REGENCY EXECUTIVE PARK SUBDIVISION,
UNIT THREE RESUBDIVISION OF LOT 2

APPLICATION NUMBER 1 DATE August 20, 2009
 APPLICANT Regency Executive Park Subdivision, Unit Three, Resubdivision of Lot 2
 REQUEST Subdivision

DETAIL SITE PLAN

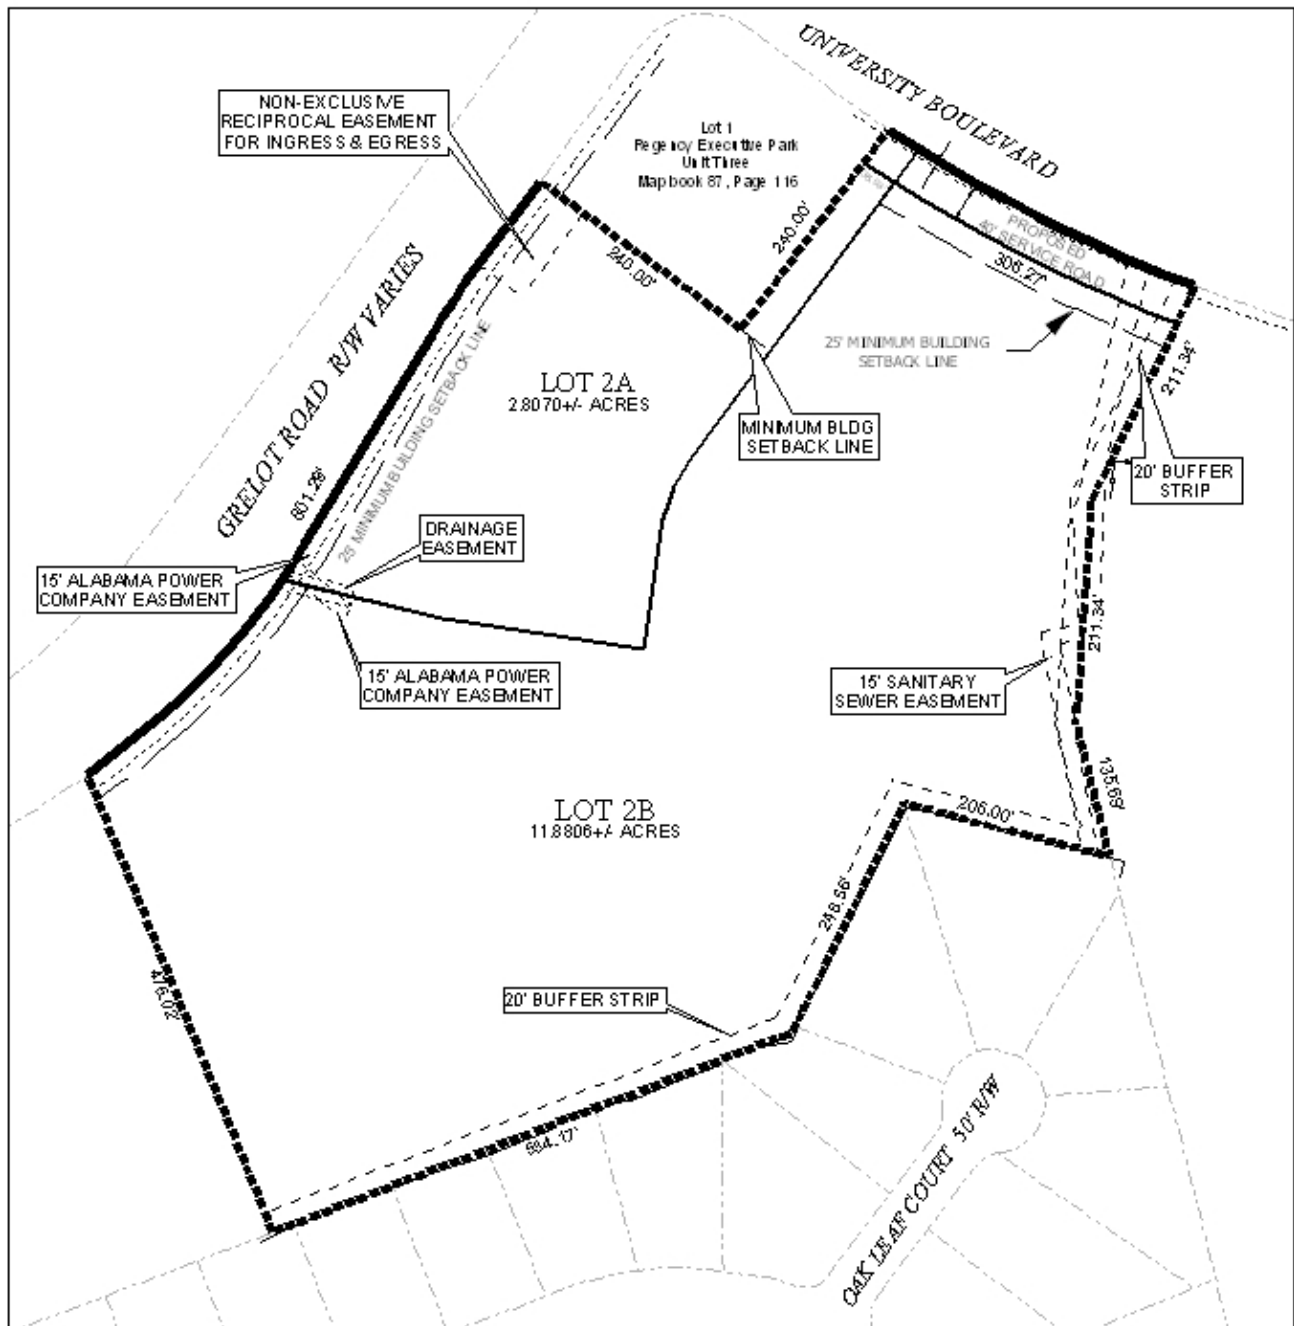
The proposed Lot 2A is illustrated as a flag lot. The proposed lot has approximately 457 feet of frontage along Grelot Road. The plat also illustrates a 35-foot wide "flagpole" from the lot to University Boulevard, presumably for access to University Boulevard. This "flagpole" seems uncharacteristic of lots in the area.

long and has little, if any, possibility of ever being extended. It is recommended that the service road that is depicted be deleted.

The recommended deletion of the service road would require the proposed Lot 2A to access University Boulevard directly. The Chevron station at the corner of University and Grelot has a driveway egress onto University Boulevard approximately 20 feet from the proposed property line. Additionally, the proposed Lot 2B of this subdivision has adequate frontage along University Boulevard to warrant a curb cut. Considering the daily traffic counts for University, as well as the proximity of the existing curb cut from the Chevron, it would seem that direct access to University from this proposed lot would be unsafe and improper. Therefore, the proposed Lot 2A should be denied access to University Boulevard. Denying access to University Boulevard would eliminate the need for the “flagpole” portion of the lot, and the plat should be revised to reflect the deletion of the “flagpole” for the proposed Lot 2A.

The 25-foot minimum building setback line is depicted correctly for both lots along Grelot Road. Because the “flagpole” portion of the lot is recommended for deletion, the setback line should be revised to reflect the new lot orientation.

- 1) Retention of the labeling of the size of the lot, in square feet, or provision of a table on the plat with the same information;
- 2) Deletion of the proposed 40-foot service road right-of-way;

- 3) Elimination of the “flagpole” portion of Lot 2A;
- 4) Retention of the 25-foot minimum building setback along Grelot Road and revision of the 25-foot minimum building setback along University Boulevard to reflect the new lot orientations;

- 5) Placement of a note on the final plat limiting Lot 2A to one curb cut to Grelot Road and limiting Lot 2B to one curb cut to Grelot Road and one curb cut to University Boulevard, with the size, location, and design of all curb cuts to be approved by City of Mobile Traffic Engineering and conform to AASHTO standards;

- 6) Placement of a note on the final plat stating that there be no direct connection between University Boulevard and Grelot Road via Lot 2B;
- 7) Provision of a 20-foot buffer to remain in its natural vegetative state where the site abuts residentially zoned property;
